ABOUT ADSP-21161N SILICON ANOMALIES

These anomalies represent the currently known differences between revisions of the SHARC ADSP-21161N product(s) and the functionality specified in the ADSP-21161N data sheet(s) and the Hardware Reference book(s).

NR002446P

4. 04000004 - TTL Input Buffer for all inputs can fail to switch from high to low transitions for core power supply VDDINT < 1.9 Volts:

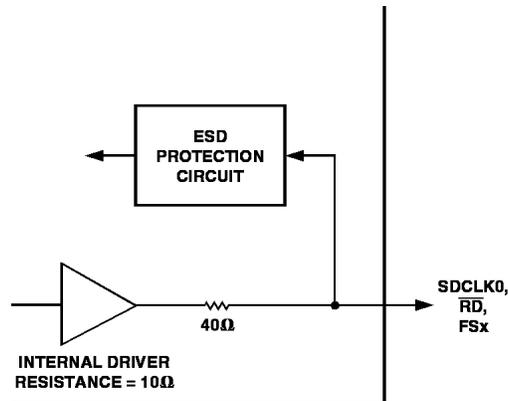
The trip point for high to low transitions in the TTL input buffer is sensitive at low temperatures and nominal core power supplied voltages for all input pins of the DSP (except CLKIN) and under these conditions the TTL input buffers can fail to transition unless the core voltage VDDINT is greater than 1.9 Volts.

To guarantee this condition does not exist for operating conditions at room temperature (25 degrees C), apply an internal core power supply voltage of VDDINT > or = 1.9 Volts to all VDDINT input pins.
